Your Ref 2015/0921/P

**CHARLIE RATCHFORD EXTRA CARE CENTRE, CROGSLAND ROAD, CAMDEN:
PLANNING APPLICATION REF: 2015/0921/P – SUBMISSION OF FORMAL RESPONSE
TO STATUTORY CONSULTEE COMMENTS**

Subject: ***Response to the Consultee letter for Planning Application (No. 2015/0921/P) - Energy***
Site name: Charlie Ratchford Extra-Care Scheme

Roof Plan
1 : 100

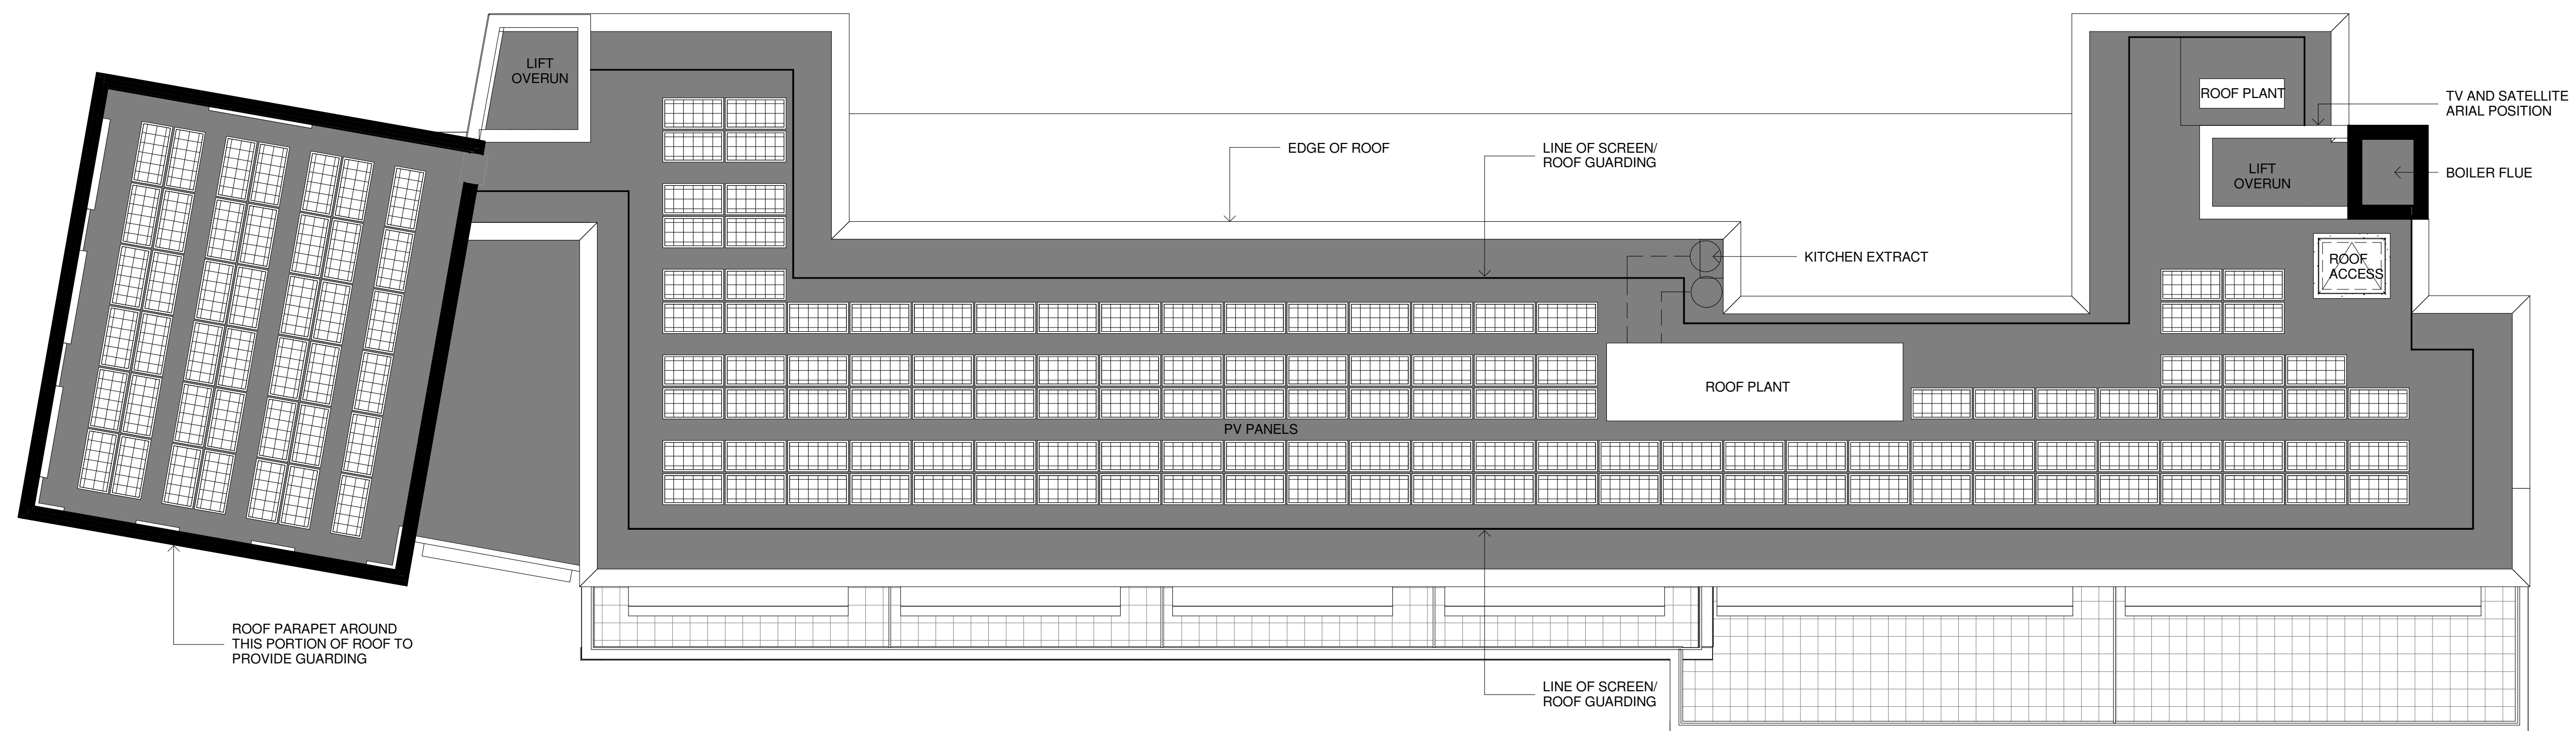
Circa 233m² PV is proposed. Appendix E of the energy statement shows that the majority of the roof would be covered in PV, however this doesn't appear to have been included on the main roof plans submitted.

Action for applicant: We need to see the proposed PV panels drawn onto a roof plan, showing proposed angle and spacing to confirm that they will not over-shade one another. This will also help to assess whether the proposed PV would be visible from the surrounding area (which may/ may not be acceptable). The applicant should also confirm power output per panel (W).

The current proposed strategy includes an installation of an area of 223 m² of Photovoltaic (PV) technology on the roof of the Proposed Development.

However, following further coordination with the design team, and in order to avoid overshadowing between arrays and to account for extra spatial requirements for mechanical roof plant, the Proposed Development would provide for 209 m² of PV panels. To compensate for the reduced area, and to ensure the same kWp output is maintained, a more efficient panel will be installed.

The PV panel that has been suggested has an output of 245W and an area of 1.244m². The 168 panels located on the roof of the Proposed Development – as demonstrated on the roof plan already provided to the council and included below for convenience – will give a total output of 41.2 kWp and are estimated to generate circa 32.4 MWh of electricity annually, offsetting circa 17 tonnes of CO₂.

The panels are to be laid horizontal (0°), specifically in order to prevent overshadowing and avert any visual impact from street level. Clear sections of the PV roof layout have also been provided to the Council.

title	Proposed Ground Floor Plan	drawn	CJP
		checked	RVP
		scale	1 : 200
drawing no	AA4796/2040A	date	JAN 15

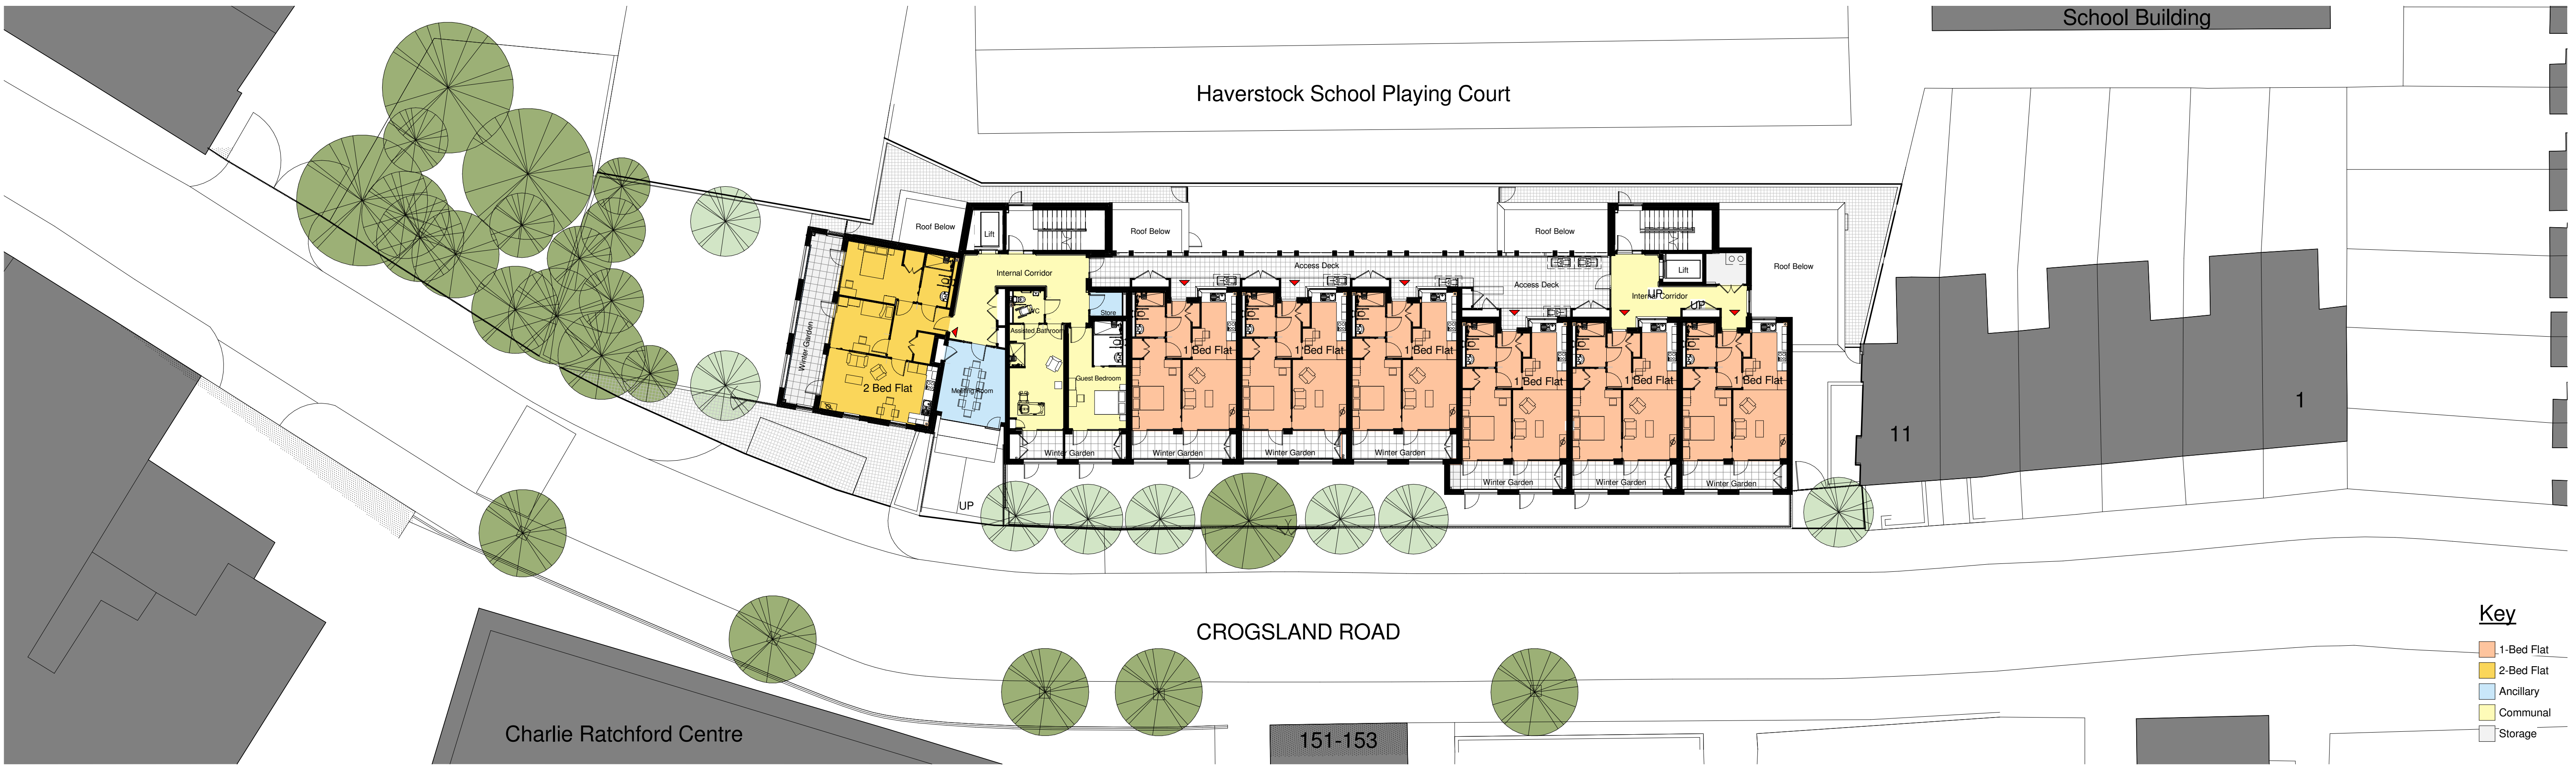
This appears accessible although the entrance paving is labelled as block paving so it is not clear how accessible this will be. This should be clarified.

- The plans have been updated to show a 300mm leading edge to the flat entrance doors and the shower room layouts include a side transfer as the shower space adjacent to the WC is an open space level access shower.
- The day centre has a block paving approach which is level and suitable for wheelchairs and walking frames.

Typical 1 Bed Apartment Layout
1 : 50

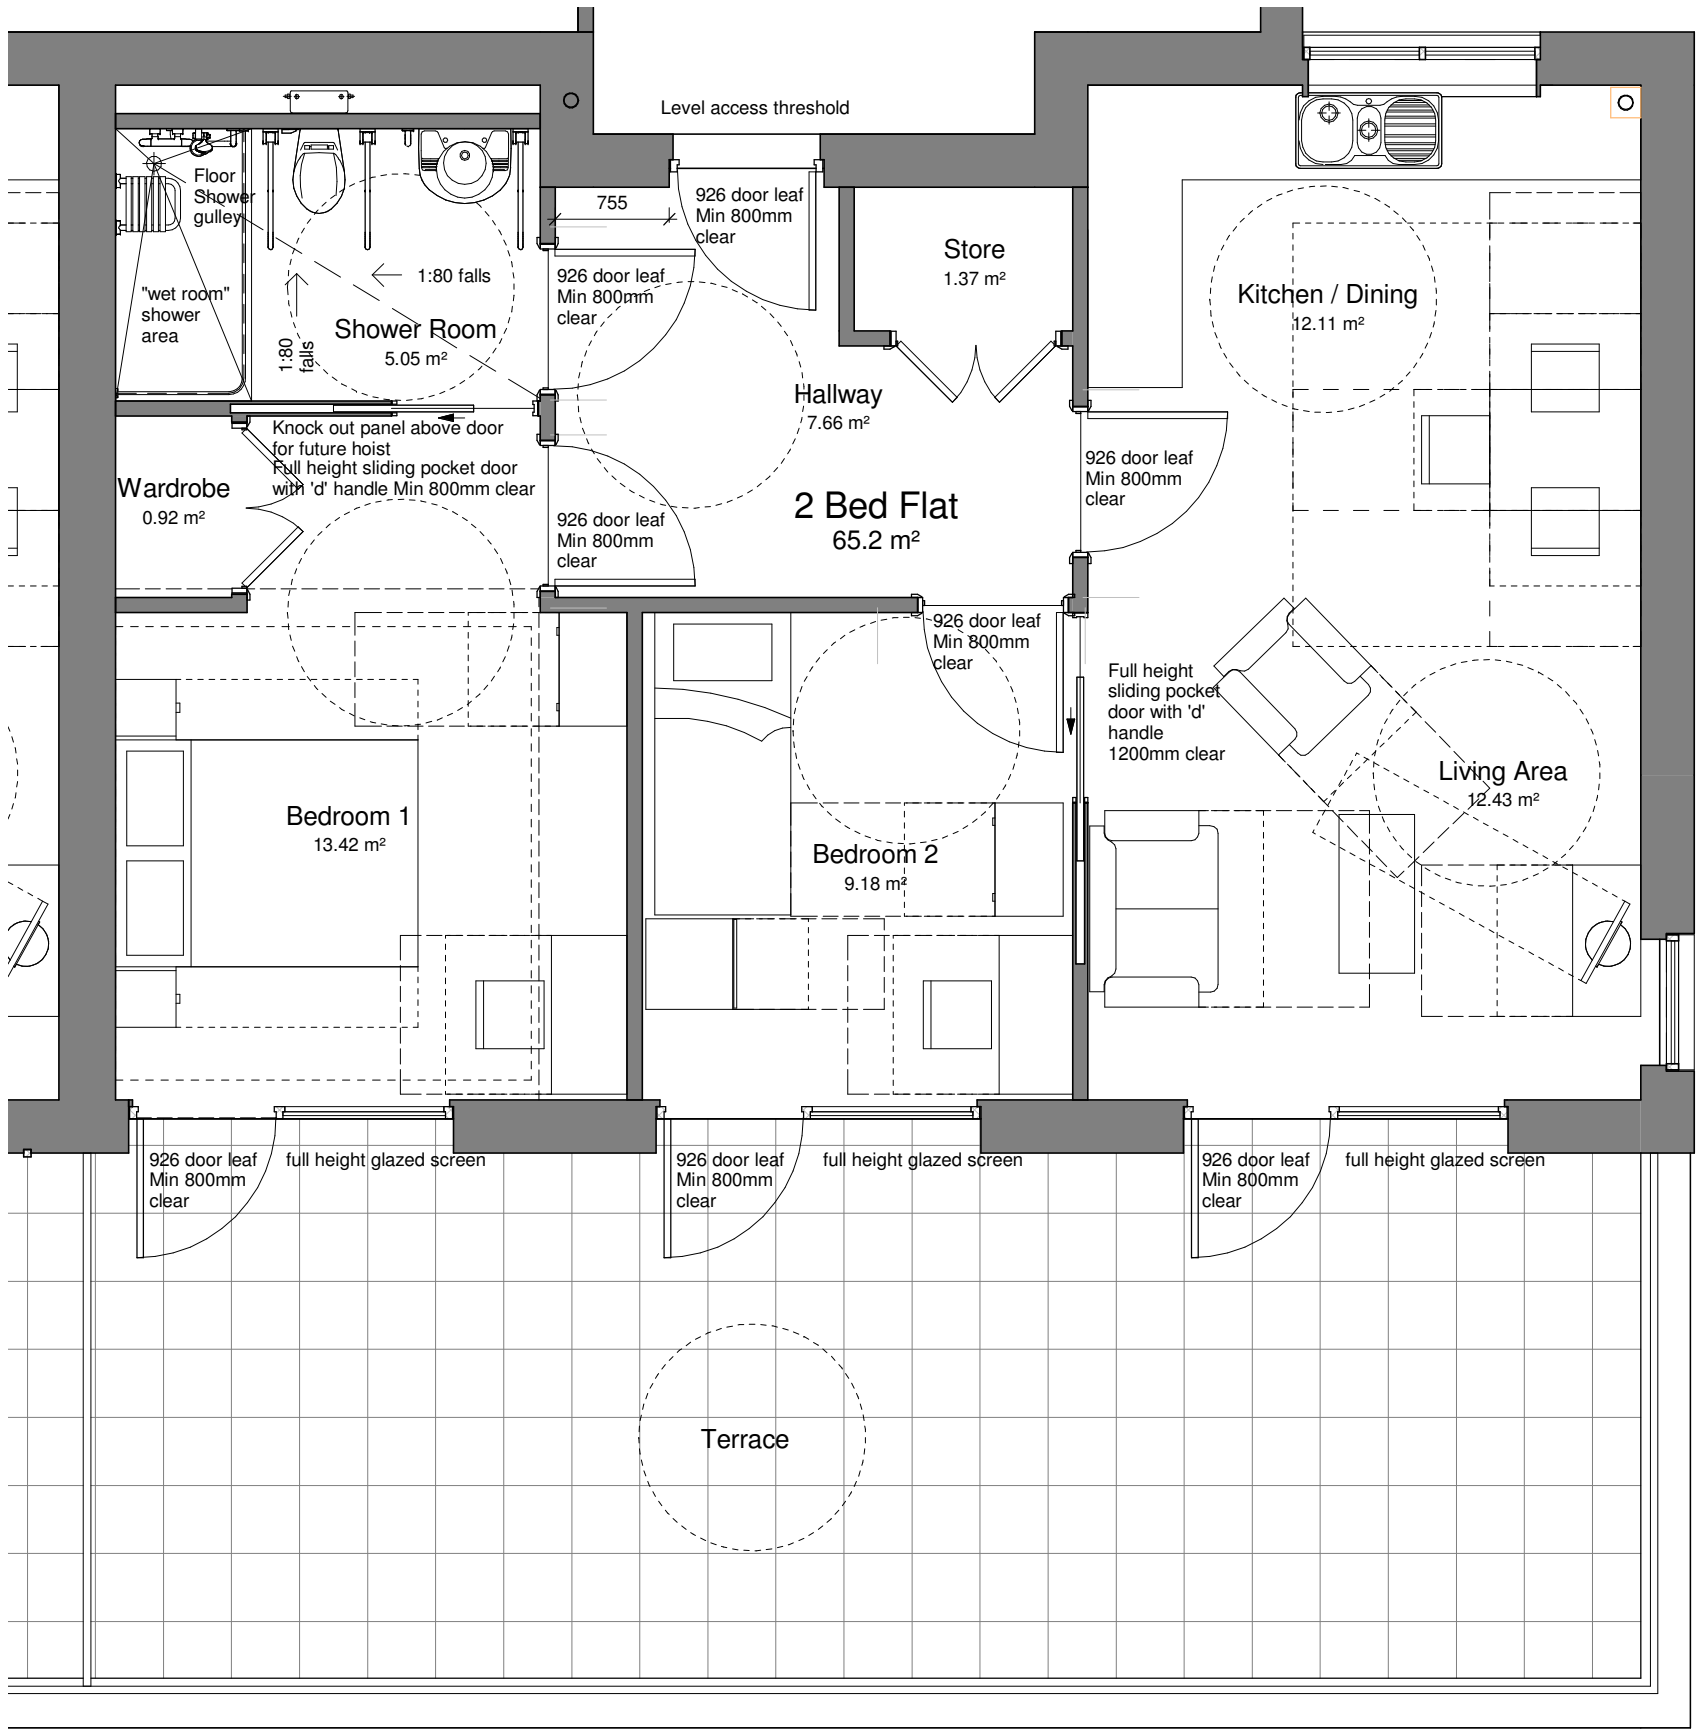
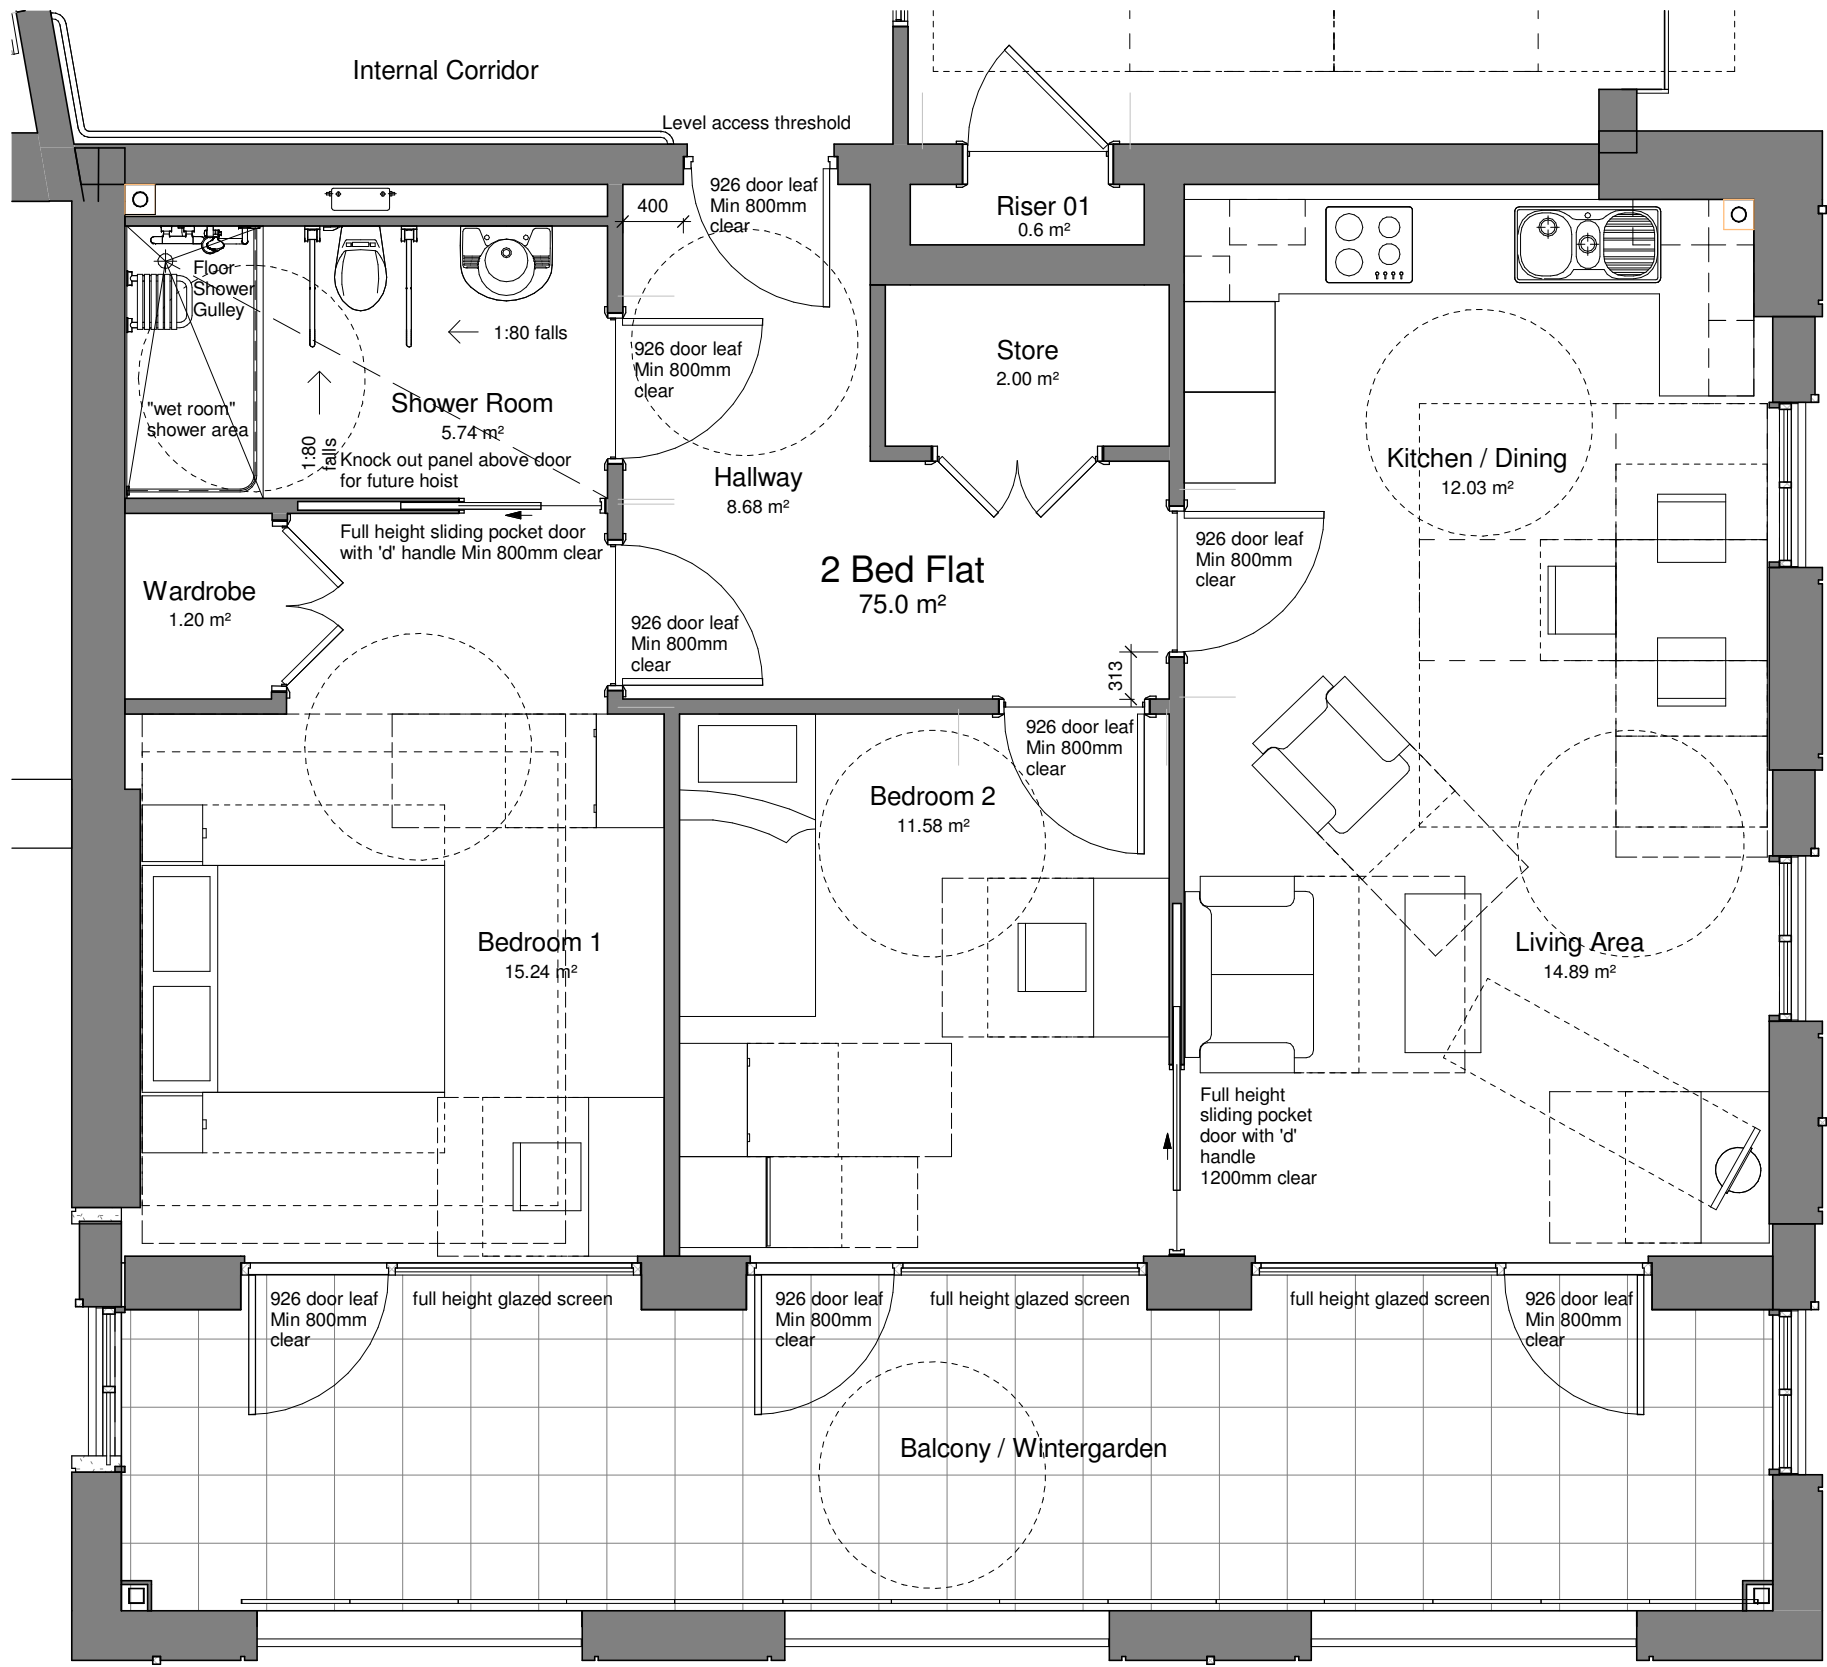
There is no confirmation that the units have been designed to Lifetime homes standards so this should be secured by condition. From the details provided the 2 requirements I can see that are not provided throughout is the 300mm clear space to the leading edge of the flat entrance doors and the side transfer space to the WC (layout doesn't meet LHS or wheelchair housing standards) Further details of this should be submitted.
